Delmore Fast Track Application

Appendix 8: A22 (Traffic Engineer) to Response to Comments letter

Re: Traffic Engineering Response Memorandum

Appendix 26b - Stage 2 Rooding and Access Drawings_ pg.5/53

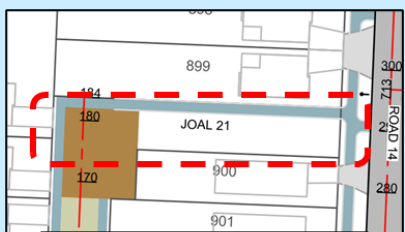
2 loading bays added adjacent lot 142. <u>Stage 2</u> <u>JOAL 21</u> - Lot 900 boundary adjusted to enable truck turning. <u>JOAL 35</u> - Lot 1214 boundary adjusted to enable truck turning.	JOAL 11 No further comments. Noted proposed loading bay adjacent to lot 204 with 6.0mx6.8m (ref: Appendix 10a - Stage 1 Scheme Plans_ pg.20/45, Appendix 26a - Stage 1 Roding and Access Drawings_ pg.8/51). This is considered acceptable. <u>Further clarification:</u> <u>Minor inconsistency, as per applicant response, the loading bay is adjacent to lot 207 (report). However, on further assessment, it is adjacent to lot 204 (plan). Request to do necessary changes.</u> JOAL 40 No further comments. Noted proposed loading bay adjacent to lot 142 with ~8.0mx5.6m (ref: Appendix 10a - Stage 1 Scheme Plans_ pg.14/45, Appendix 26a - Stage 1 Roding and Access Drawings_ pg.6/51). This is considered acceptable. Stage 2 JOAL 21 No further comments. Noted proposed truck turning area adjacent to lot 900 with ~15mx12m dimensions

(ref: Appendix 10b - Stage 2 Scheme plans_ pg.45/49, Appendix 26b - Stage 2 Rooding and Access Drawings_ pg.5/53). This is considered acceptable.

Request to update the inconsistency in the scheme plan of JOAL 21 and lot 899.

bay arrangement can be noted on site apart from parking on JOAL- which blocks adjacent driveways, mainly the loading bay can be utilised for residential delivery type of customers including furniture movement- as no loading bay is available- users may parking unsafe & create more obstructions, no existing on-street loading bay is noted in the vicinity of the site, it's illegal to park on the kerb side of JOAL [as per right to establish and maintain driveway- 2(c) of Schedule 5 to the Property Law Act 2007], no specified location can be noted where informal or another site in the immediate vicinity can be utilised for loading bay without breaking the law, provision of loading bay will be always useful for a large community like Delmore, the provision of a designated loading bay will always support efficient usage, I am not in a position to support the non-compliance of the loading bay. Additionally, the parking of heavy vehicles will block the VC of the adjacent lot. Any furniture delivery or house relocation will take more than a minimal time. This has been discussed in the previous stage, and the applicant team agreed to provide the required loading bay prioritising at the JOALs with a high number of dwellings and length.	- Lot 474 boundary adjusted - loading bay (full) added to the north. <u>JOAL 02</u> - Lot 478 and 470 boundary adjusted - truck turning enabled. <u>JOAL 03</u> - Loading zone (full) provided in South - Lot 96 boundary adjusted. <u>JOAL 06</u> - Lot 373 boundary adjusted to enable a loading zone to be provided (full). <u>JOAL 11</u> - Lot 207 boundary adjusted to provide a full loading bay. <u>JOAL 40</u> - No boundary adjustments.	Appendix 10a - Stage 1 Scheme Plans_ pg.3/45, Appendix 26a - Stage 1 Rooding and Access Drawings_ pg.4/51). This is considered acceptable. <u>JOAL 02</u> No further comments. Noted proposed turning area adjacent to lot 478 with ~22.0m length (ref: Appendix 10a - Stage 1 Scheme Plans_ pg.3/45, Appendix 26a - Stage 1 Rooding and Access Drawings_ pg.4/51). This is considered acceptable. <u>JOAL 03</u> No further comments. Noted proposed loading bay adjacent to lot 96 with 8mx5.2m (ref: Appendix 10a - Stage 1 Scheme Plans_ pg.8/45, Appendix 26a - Stage 1 Rooding and Access Drawings_ pg.6/51). This is considered acceptable. <u>JOAL 06</u> No further comments. Noted proposed loading bay adjacent to lot 96 with 4.5mx9.3m (ref: Appendix 10a - Stage 1 Scheme Plans_ pg.36/45, Appendix 26a - Stage 1 Rooding and Access Drawings_ pg.5/51). This is considered acceptable.	clarification on. This is included below: - For JOAL 11, this is correct, the loading bay is adjacent to Lot 204 (as opposed to Lot 207 as incorrectly stated in the previous response). No updates to the plans are needed. - For JOAL 21, the name of the JOAL on the scheme plan is "Lot 1532". Therefore, no updates to the plans are needed.
